Marine Notice No. 37 of 2012

Recall of Mullion "Compact 150N ISO 12402" - Lifejacket

MULLION TECHNICAL SAFETY ALERT

COMPACT 150N ISO 12402-LIFEJACKET

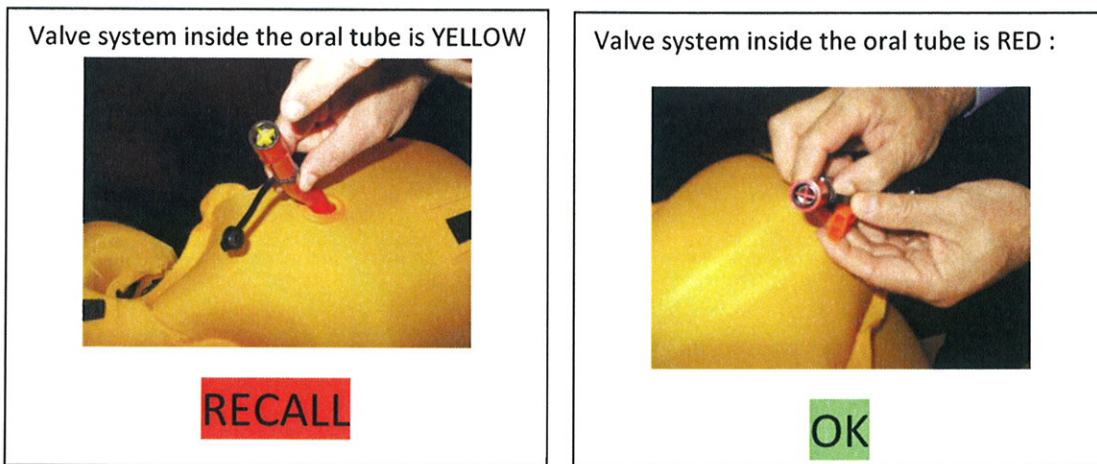
In order to avoid any potential safety issue, Mullion is recalling COMPACT-lifejackets which have been sold since 1st December 2011 if they have a yellow valve in the oral tube (see picture on the left below).

COMPACT lifejackets having a red valve in the oral tube are not affected and are not subject to this recall (see picture on the right below).

This problem arose after a design change on the oral tube initiated by our supplier. Although this new design oral tube is a fully approved and certified product, we have noticed there may be a malfunction of the lifejacket upon inflation.

The affected lifejackets are being recalled as a precaution for inspection and, where appropriate, repair or replacement.

NOT USE THEM.

RETURN them to the nearest Mullion Lifejacket Service Station or the Mullion factory in Ireland as per the listings and details on our website at www.mullion-pfd.com under the heading **COMPACT LIFEJACKET RECALL** or click on the following link : <http://www.mullion-pfd.com/compact-life-jacket-recall-programme>
